Addendum No.: 4

York Correctional Institution Central Plant and Piping Distribution

BI – JA – 465

The following clarifications are applicable to drawings and specifications for the project referenced above.

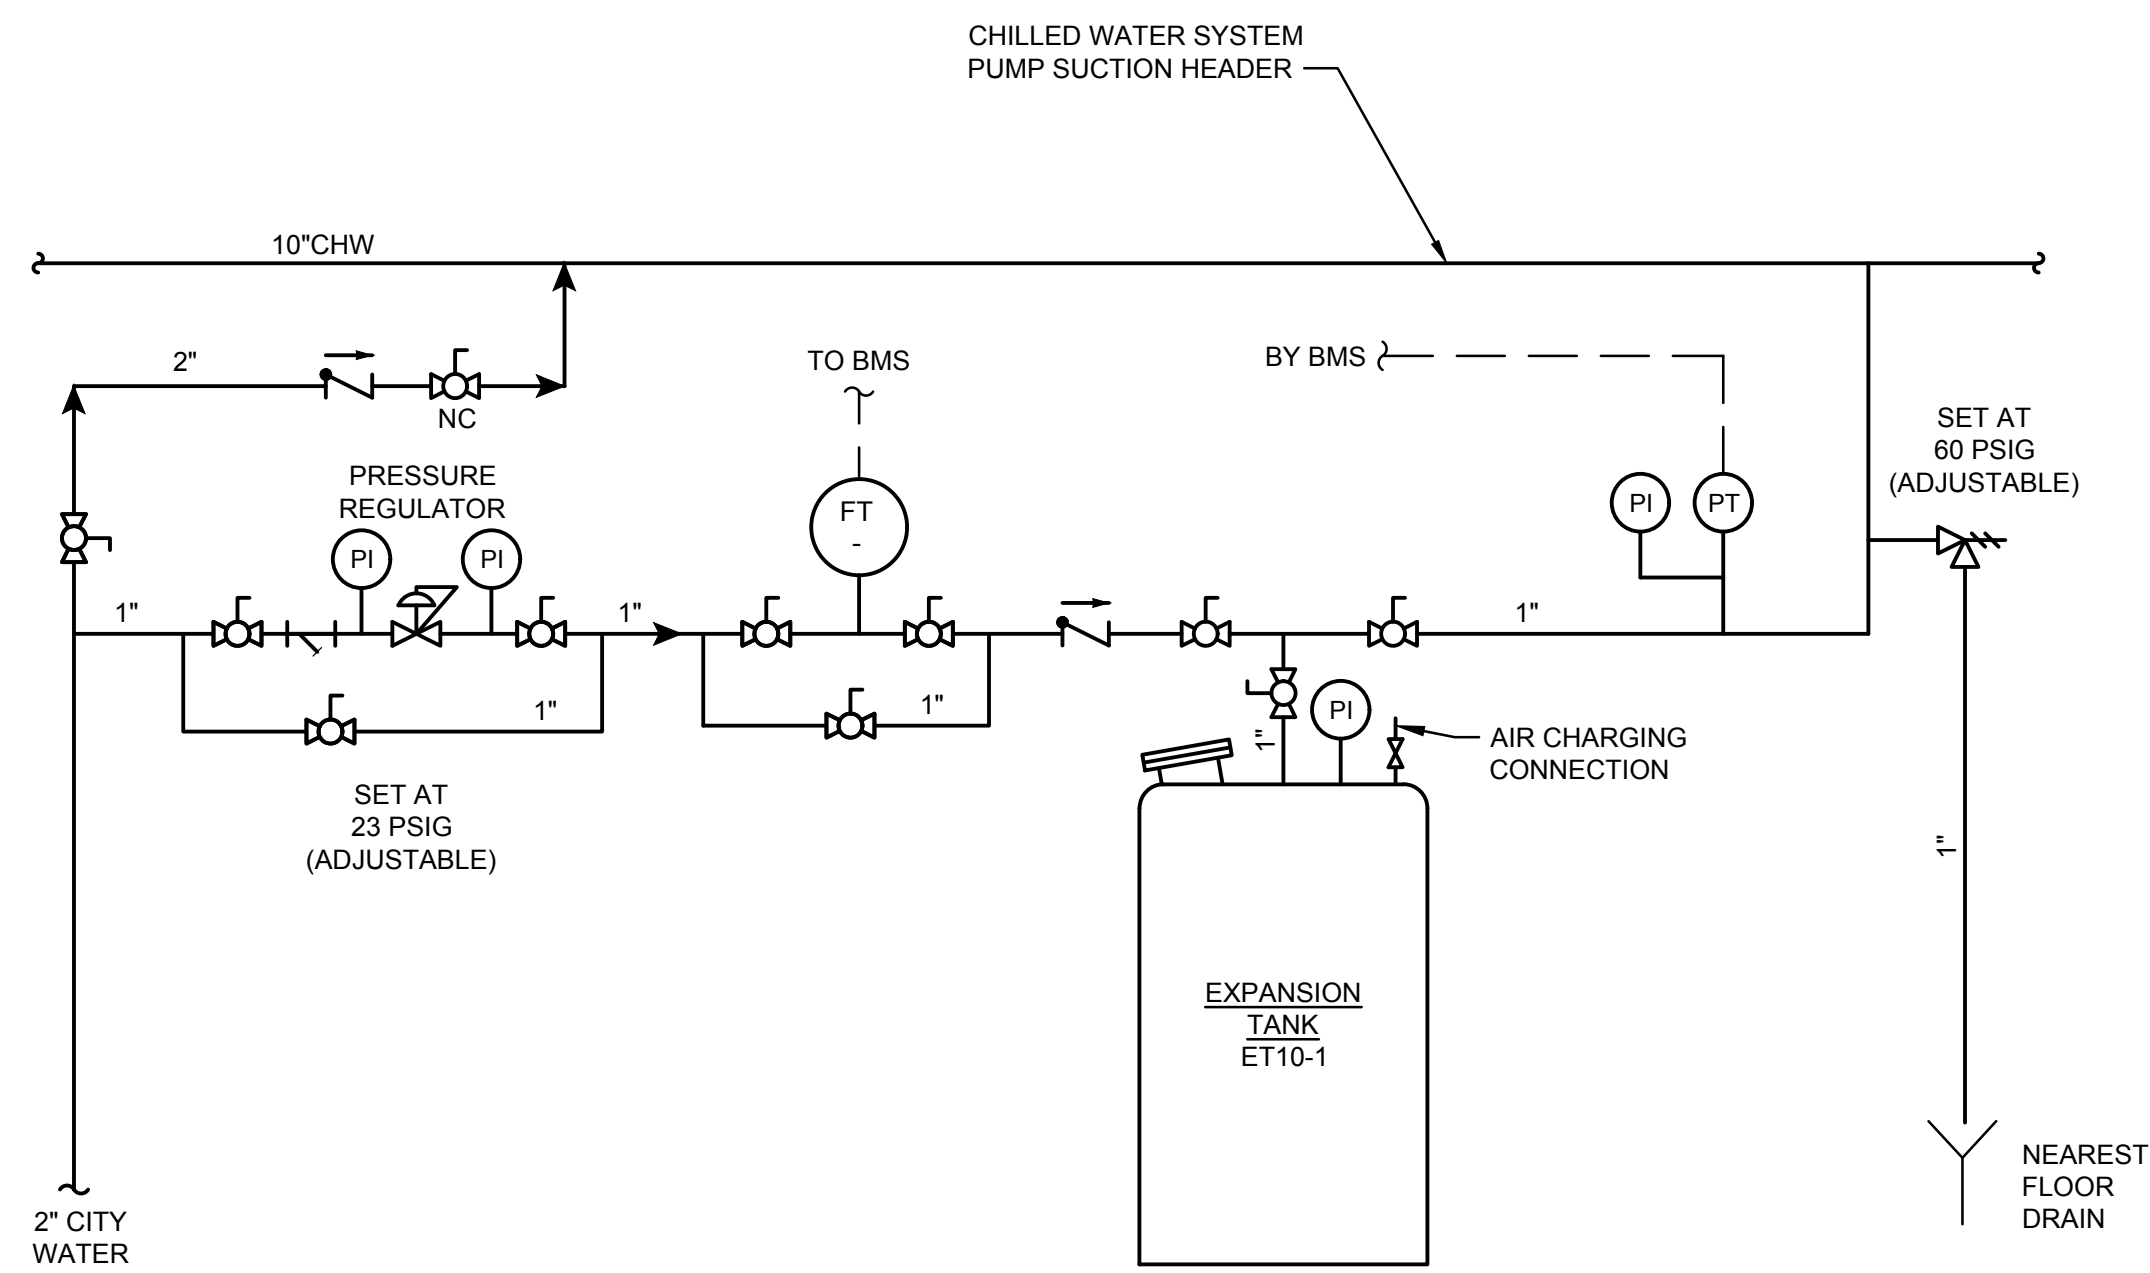
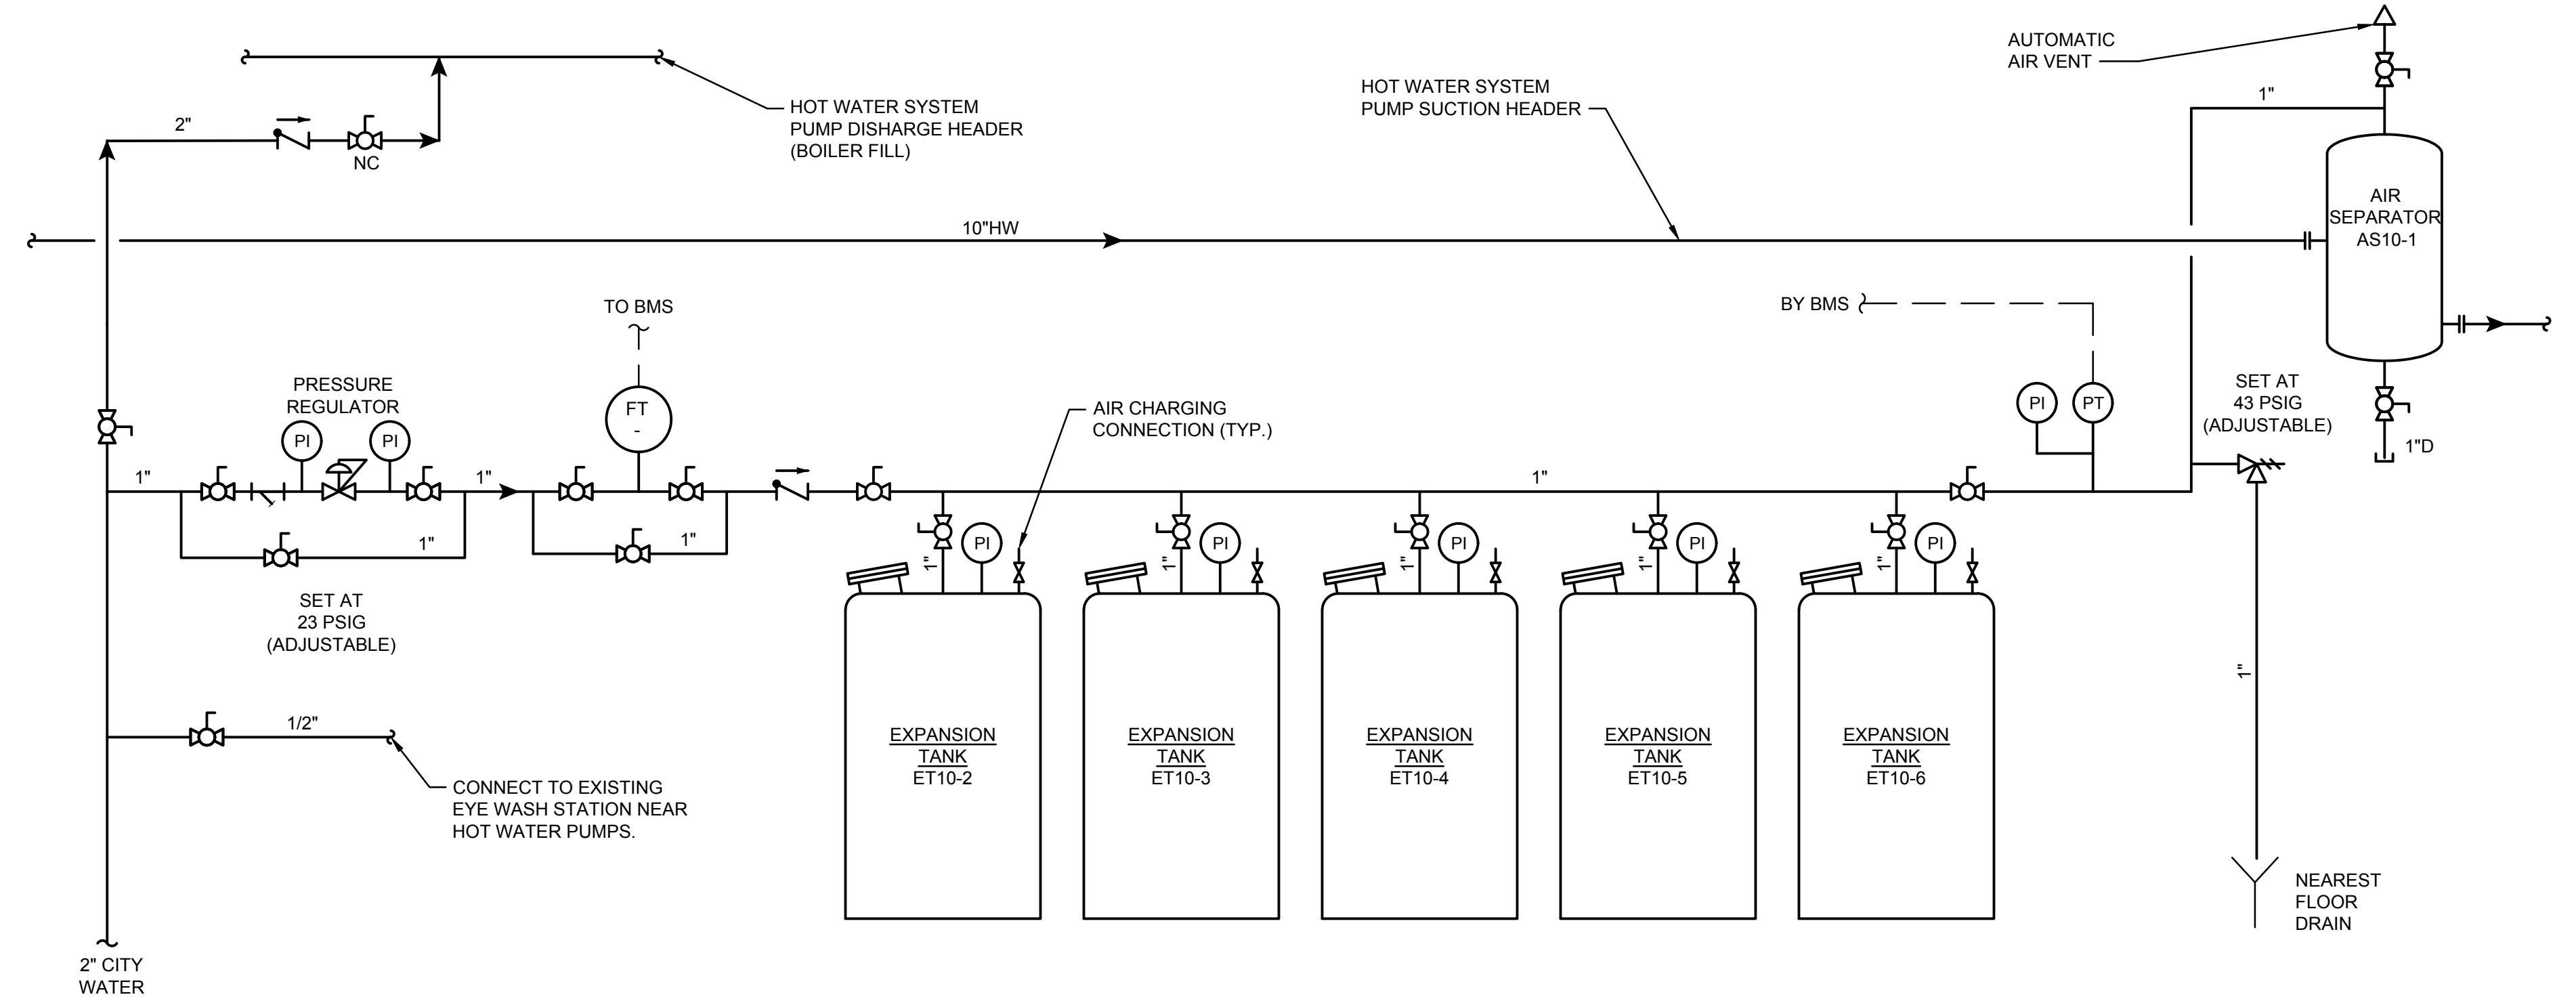
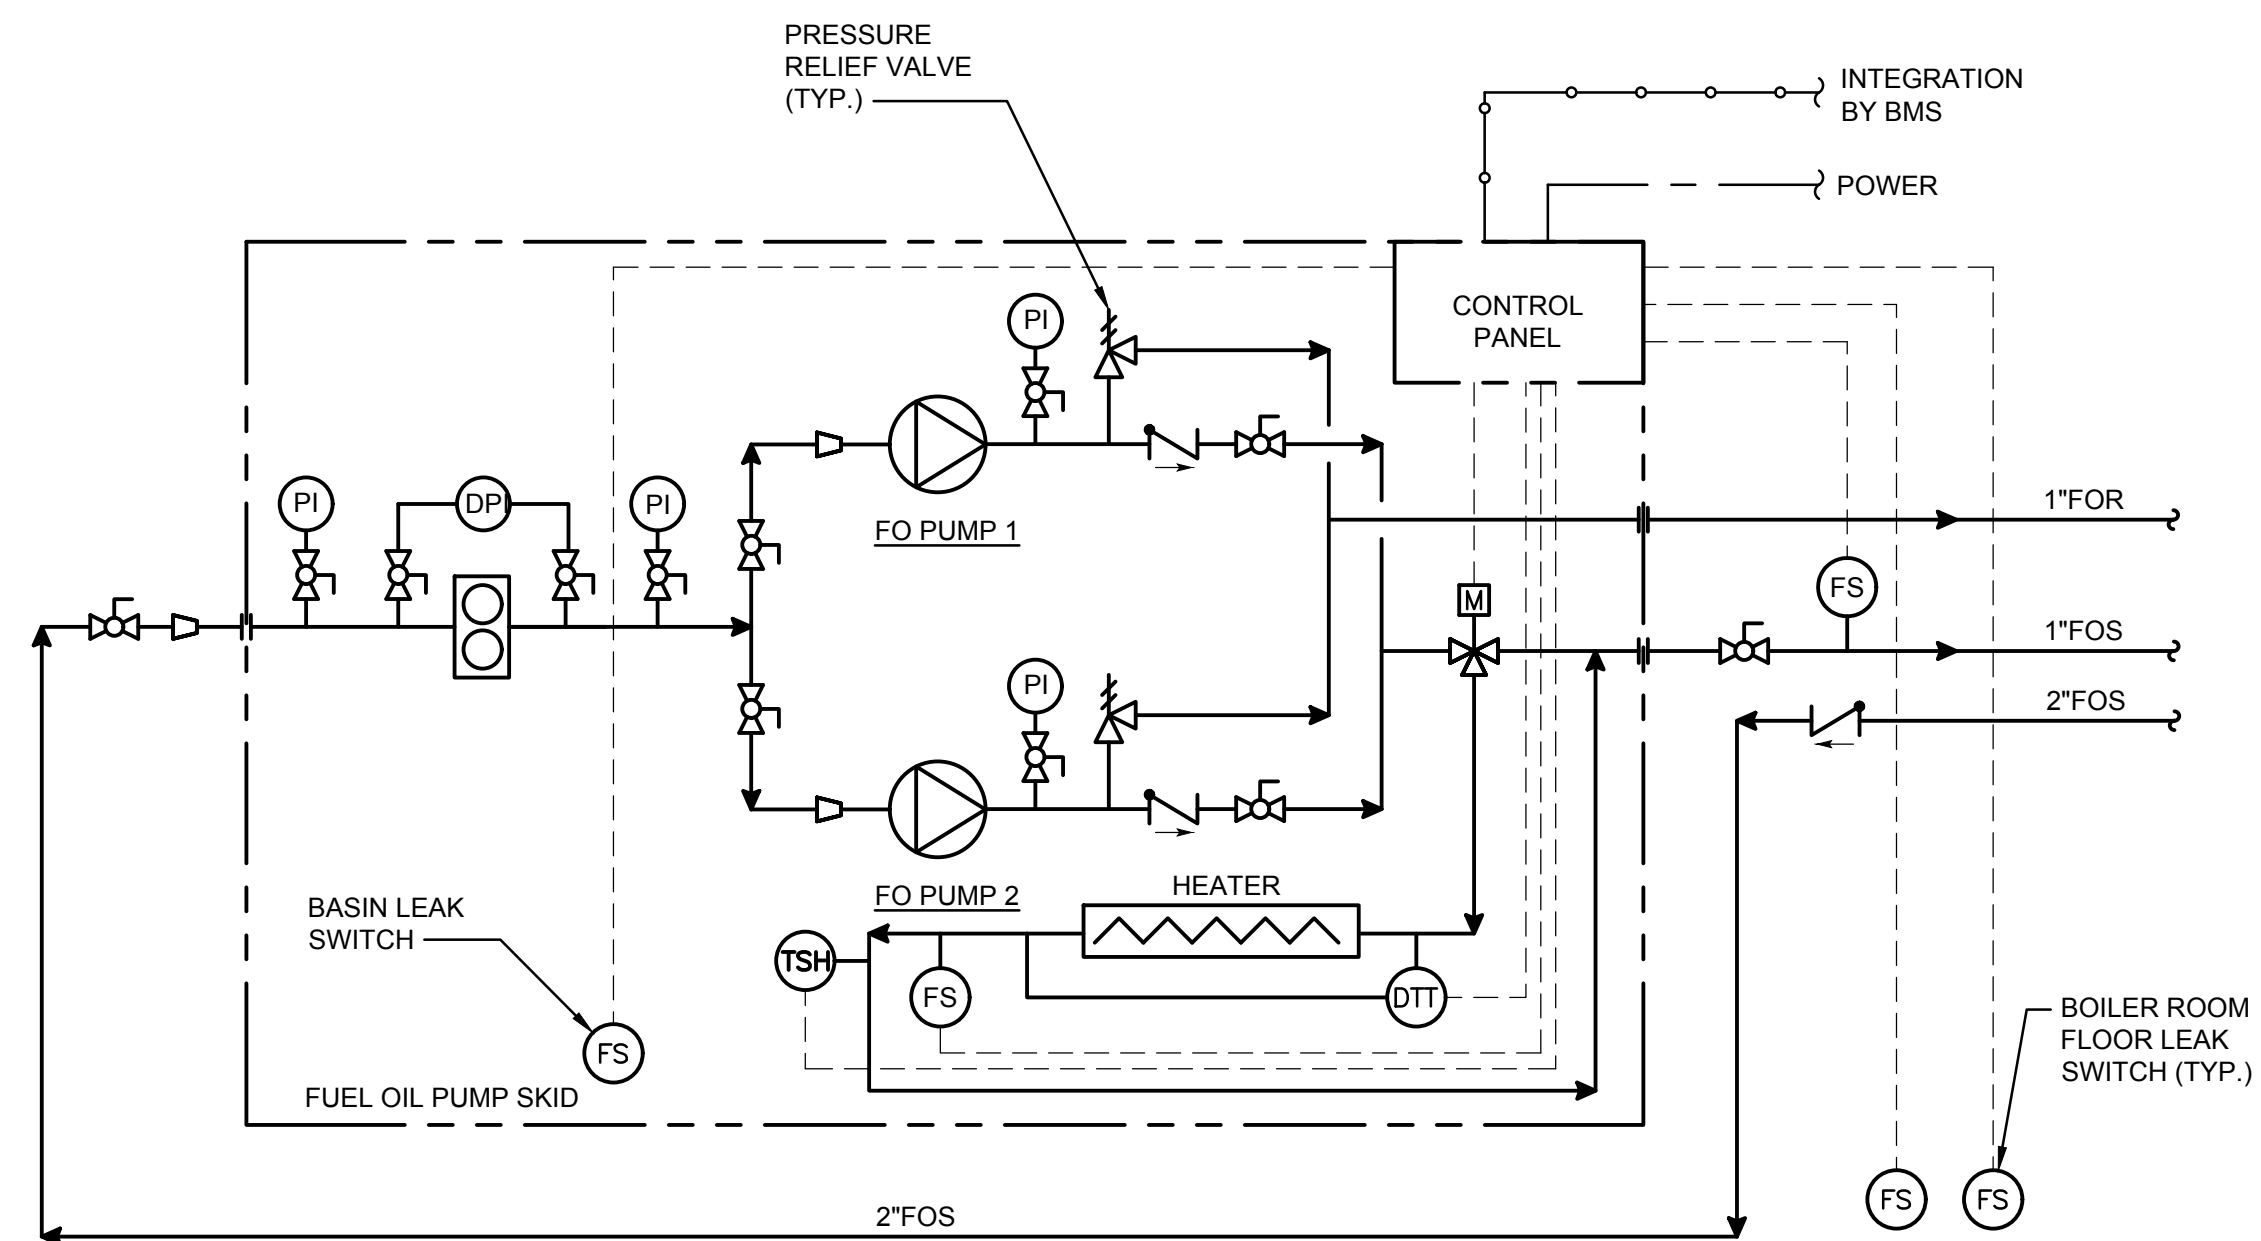
Drawing M903 Details - 4

**REPLACE** the entire drawing with the attached.

**UPDATED** detail 5 in response to pre-bid questions Q84, Q85, and Q92.

- **Q84: (23A) Is doghouse piping Detail 5/M903 required on 10" HW & 10" CHW at Building 10 Warehouse on M513?**

- **Q85: (23A) Is doghouse piping Detail 5/M903 required on 10" HW & 10" CHW at Building 8 on M516?**

A84: No. For Building 10 doghouse the piping only passes through. Detail 5, Dwg M903 has been updated as part of this Addendum.

A85: No. For Building 8 doghouse the piping only passes through. Detail 5, Dwg M903 has been updated as part of this Addendum.

A92: Bypass piping shall be installed in building 0 doghouse only as noted in detail 5, dwg M903 which has been updated as part of this Addendum.
